TekTip

Wiring suggestions for SM201B Master Station

Wiring Suggestions for the SM201B Master Station when experiencing AC Hum upon connection of an AC Powered Electric Door Strike

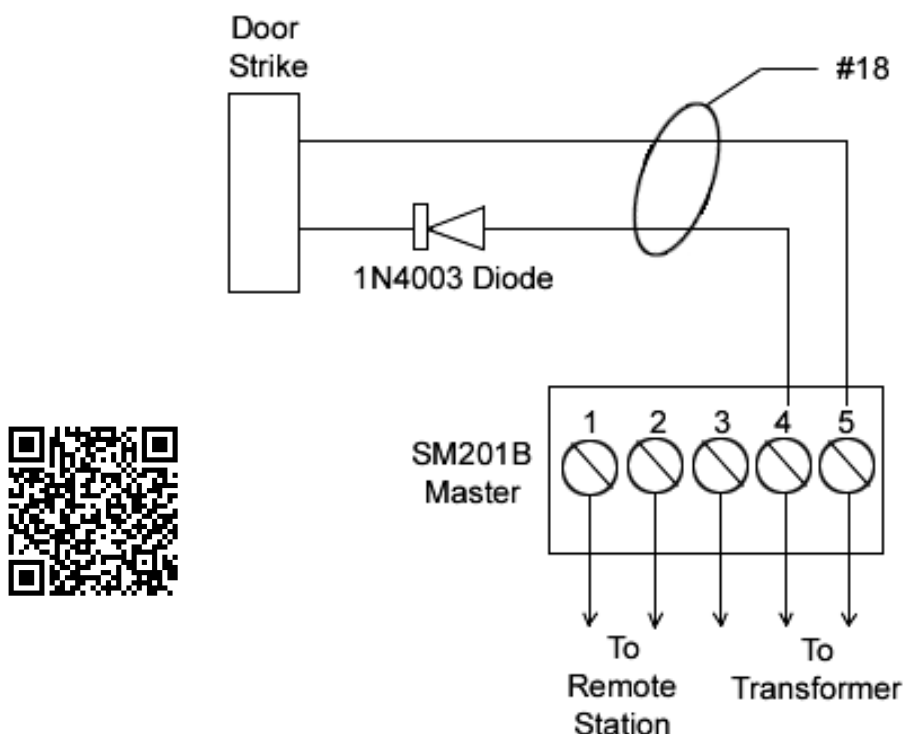
Regarding system wiring for SM201B Master Stations with a door release and door station, it is not recommended that wiring to the door strike and to the door speaker be run in the same cable.

It has come to our attention that many installations have been wired in this manner, resulting in interference problems. In order to alleviate, and in some cases eliminate the problem, a 1N4003 diode (TekTone® part no. 027) can be installed in series with the door strike wire coming from terminal 4 on the SM201B Station.

For new installations, if it is desirable to have the door strike and door speaker wires in the same cable, the door speaker wires should be shielded.
